Re: Initial Submission Review – Highline Village Subdivision Filing No 3 – Plat Amendment
Application Number: **DA-2228-00**
Case Number: **2020-3013-00**

Initial Submission Review

HIGHLINE VILLAGE

LA□D□CAP□
D□TAIL□

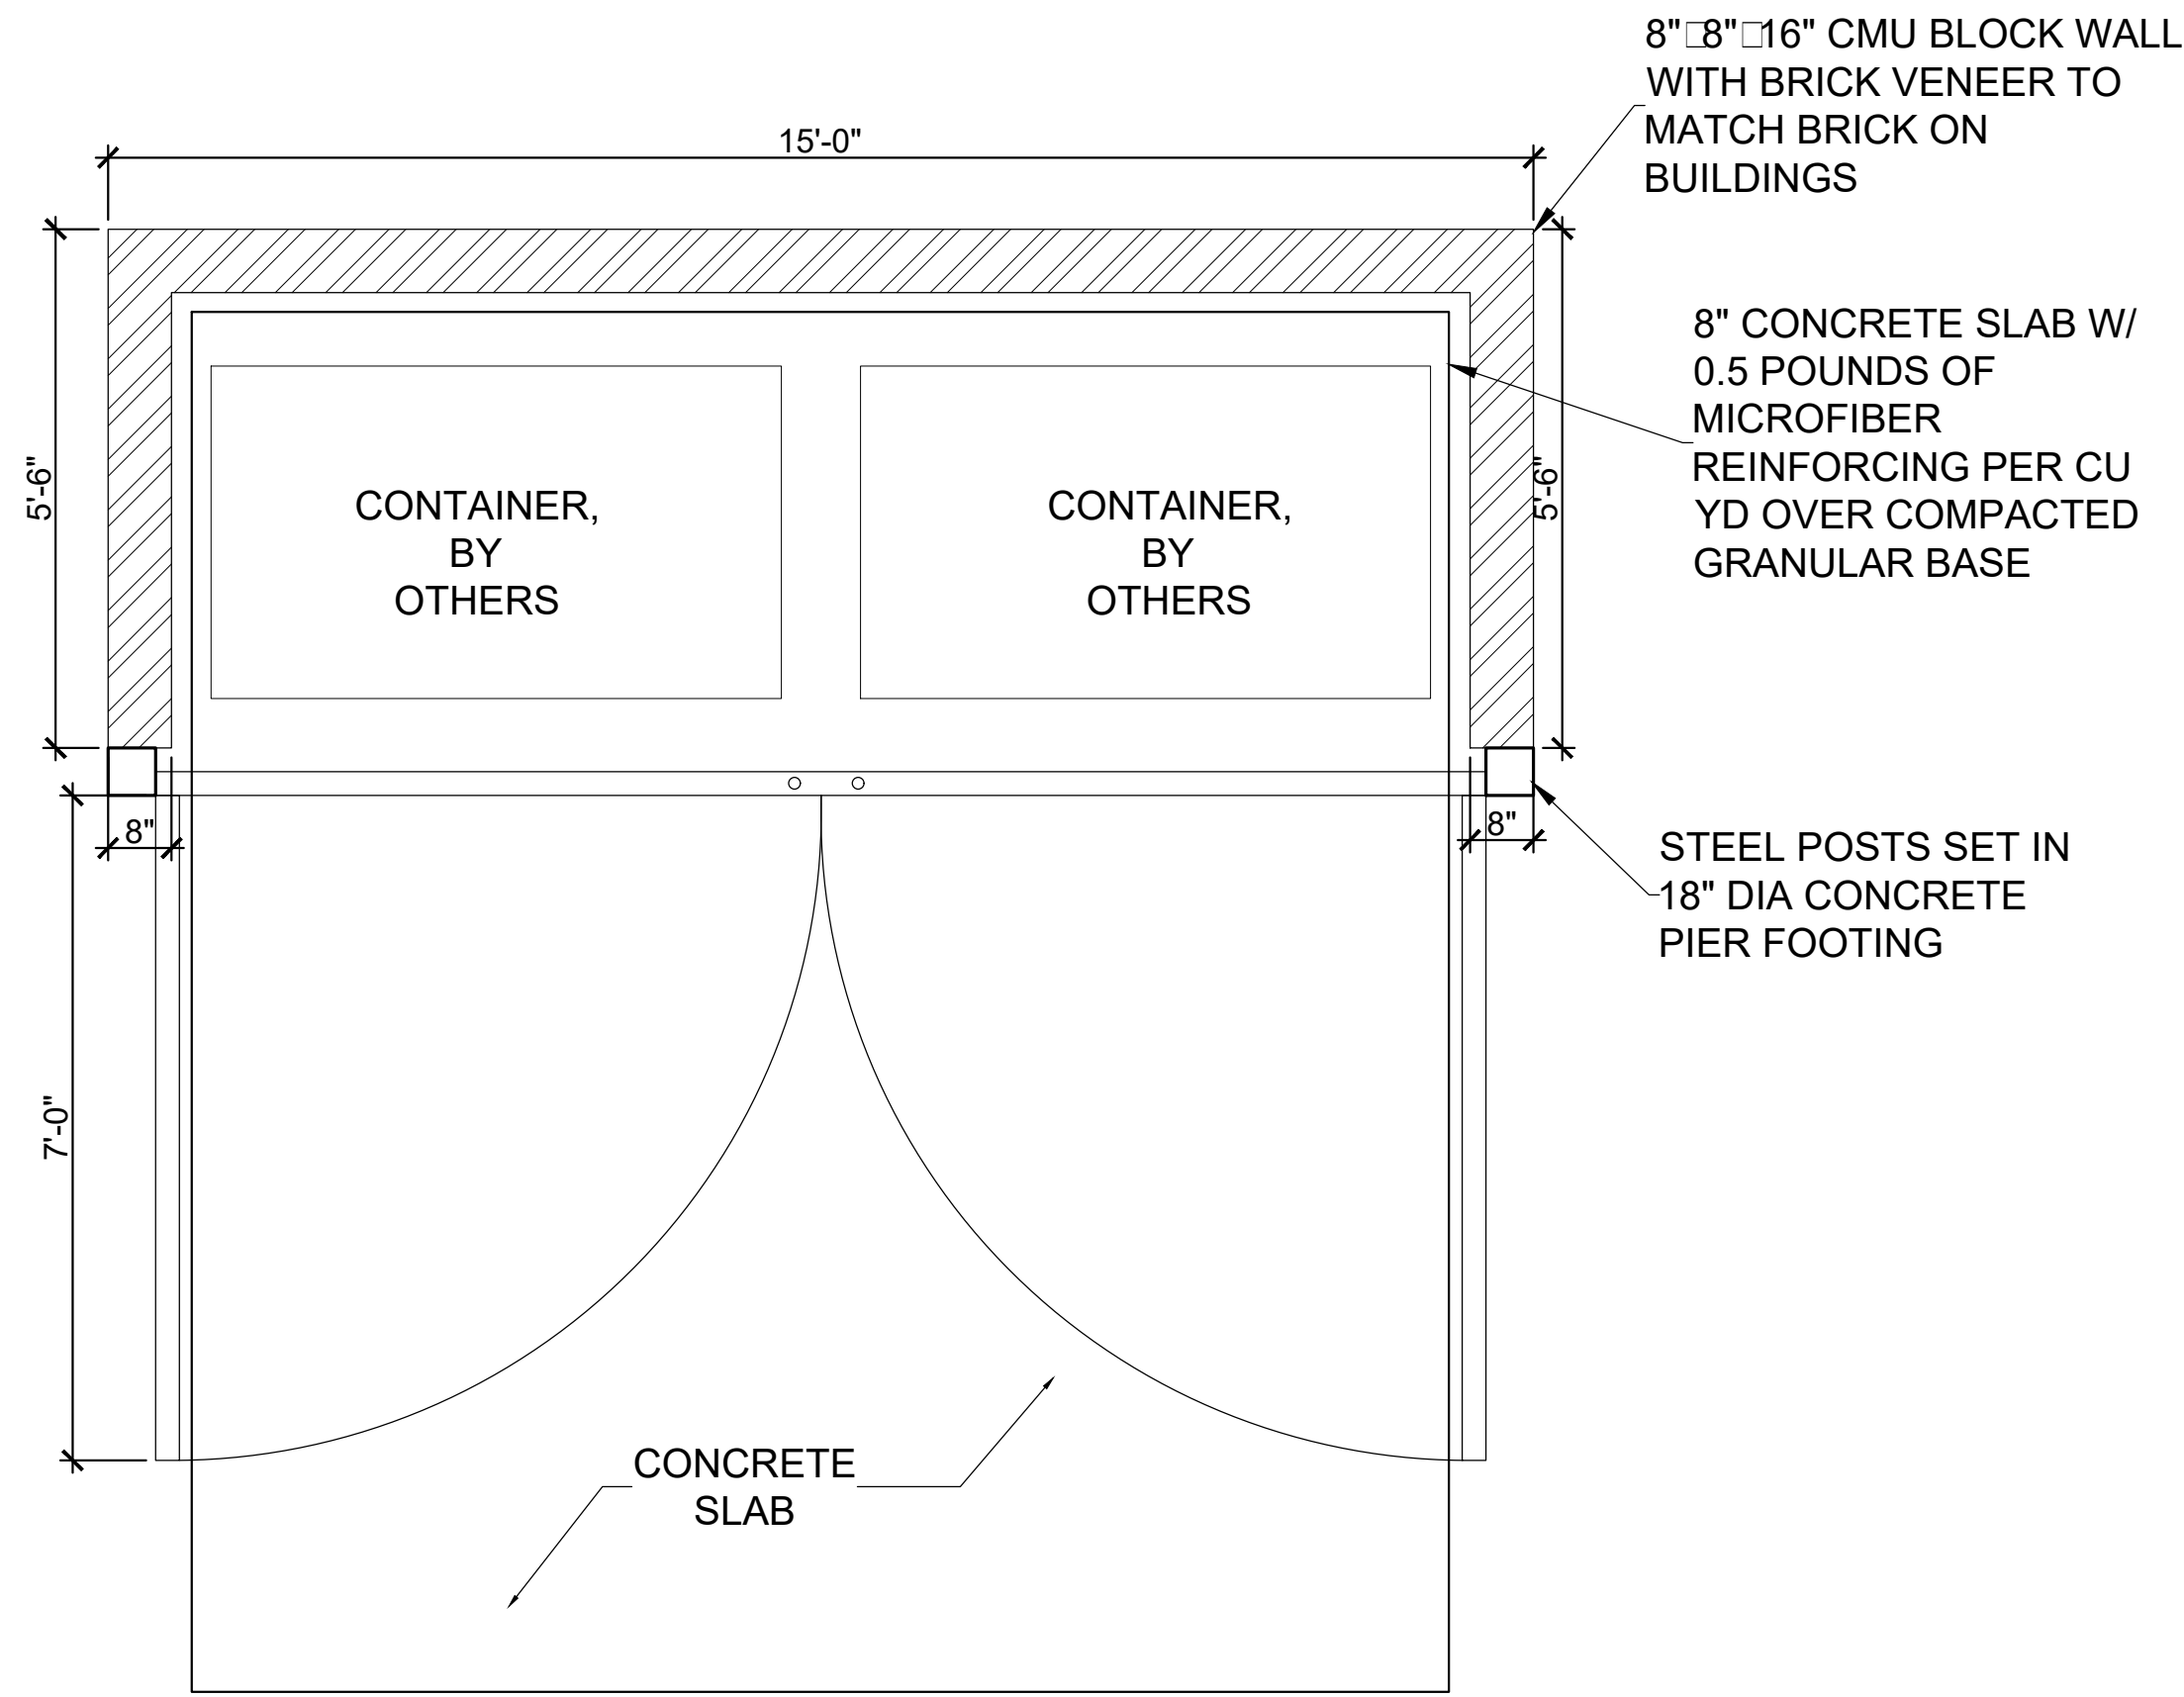
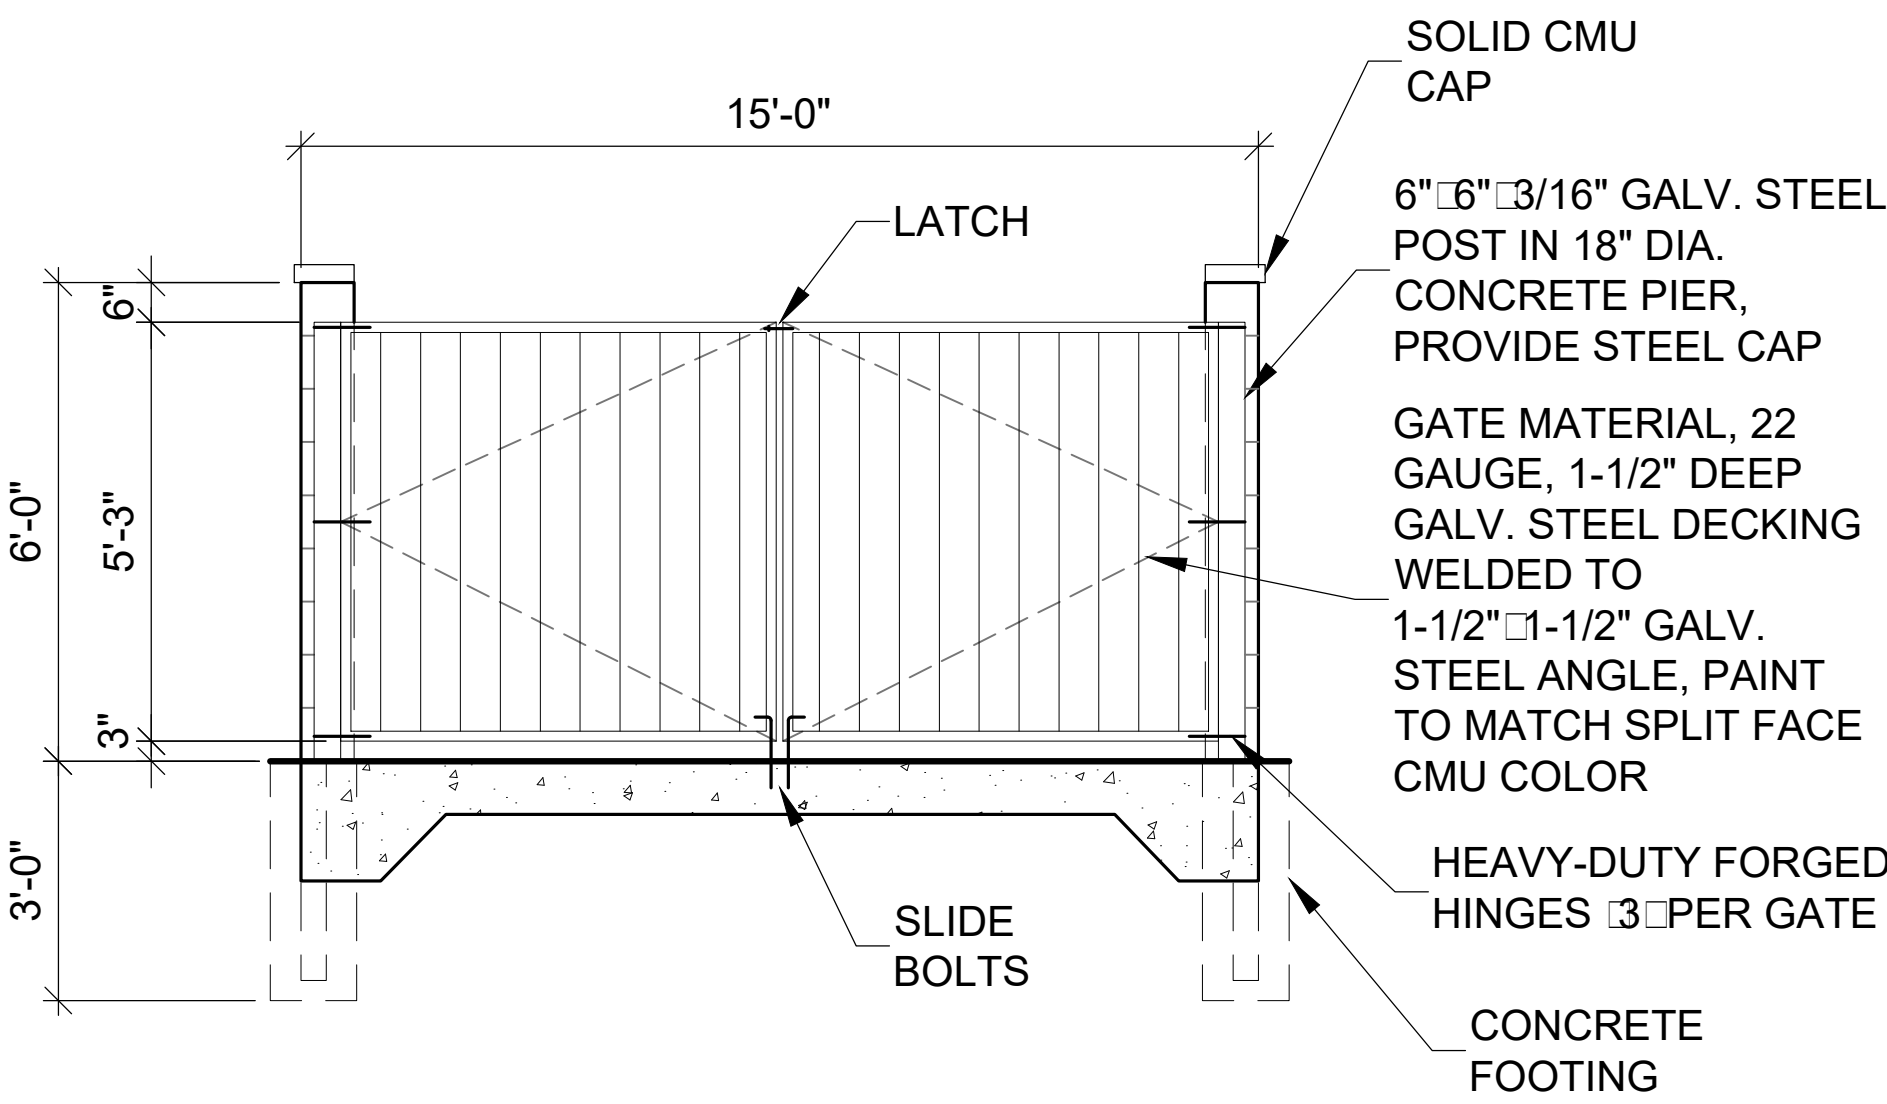
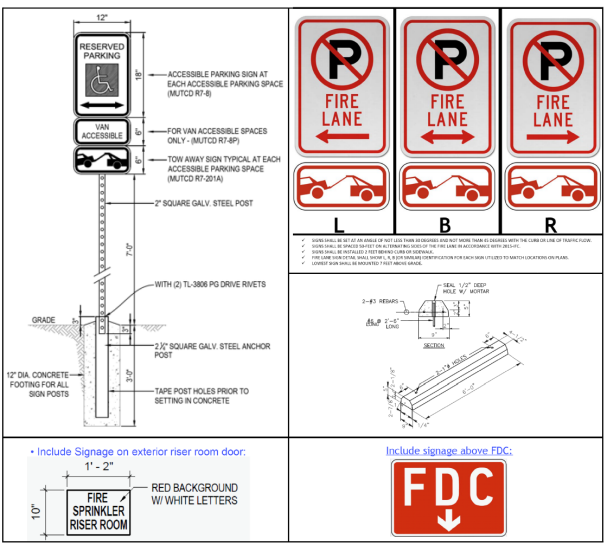
Include a section of the retaining wall

Provide a detail of your mail kiosks on this sheet. Provide enough detail to reflect the accessibility requirements of sidewalks to meet ICC A117.1.

Provide sign package detail. See below for reference.

RETAINING WALL HAS BEEN ADDED ON THE FENCING SHEET -RICK

MAIL KIOSK INFORMATION AND DETAIL HAS BEEN ADDED-RICK

SIGN PACKAGE HAS BEEN INCLUDED IN CIVIL DRAWINGS. -RICK
